# United States Patent and Trademark Office

APPLICATION NO.	FILING DATE	FIRST NAMED INVENTOR	ATTORNEY DOCKET NO.	CONFIRMATION NO.
10/516,329	12/14/2004	04 Rene Walter 263119		8633
22850	7590 01/13/2006		EXAMINER	
OBLON, SPIVAK, MCCLELLAND, MAIER & NEUSTADT, P.C.			KOVACS, ARPAD F	
	SIREET SIA, VA 22314	ART UNIT	PAPER NUMBER	
	,	,

Applicatio	n No.	Applicant(s)				
		10/516,32	9	WALTER ET AL.				
	Office Action Summary	Examiner		Art Unit				
		Árpád Fáb	ián Kovács	3671				
The MAILING DATE of this communication appears on the cover sheet with the correspondence address Period for Reply								
A SHORTENED STATUTORY PERIOD FOR REPLY IS SET TO EXPIRE 3 MONTH(S) OR THIRTY (30) DAYS, WHICHEVER IS LONGER, FROM THE MAILING DATE OF THIS COMMUNICATION.  - Extensions of time may be available under the provisions of 37 CFR 1.136(a). In no event, however, may a reply be timely filed after SIX (6) MONTHS from the mailing date of this communication.  - If NO period for reply is specified above, the maximum statutory period will apply and will expire SIX (6) MONTHS from the mailing date of this communication.  - Failure to reply within the set or extended period for reply will, by statute, cause

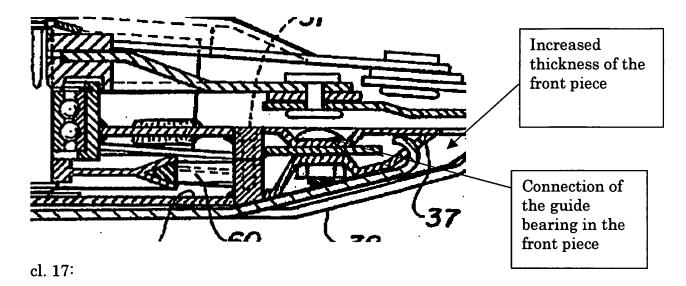
a gearbox having an upper (34) & lower (33) & front piece (guard member 37, 37a) that is thicker than the upper part (see at increased part 37a in fig 6, also see bellow);

at least one guide bearing connected to the gearbox by assembly elements (bearing 43, assembly elements as shown in fig 6);

cutting member (47) rotating about a vertical axis (fig 6);

the assembly elements configured to connect the guide bearing to the gearbox is anchored in the front piece (see bellow);

the upper & lower parts have substantially same thickness (see fig 6, 7);

at the front, the upper & lower parts joint together by the front piece (see fig 6, 7);

at the rear, the upper & lower parts directly joined together (see at the rear end of the casing, at ref 32);

welding is used to connected the front piece & upper & lower parts (fig 6);

the guide bearing is arranged above the gearbox (see at ref 43, 76);

anchoring comprises a pin, first & second threaded part & designed in a manner claimed (as shown a nut & bolt & inherent washer, see drawing above), so that the O-ring or washer is flattened when bolt is tightened in inherent manner;
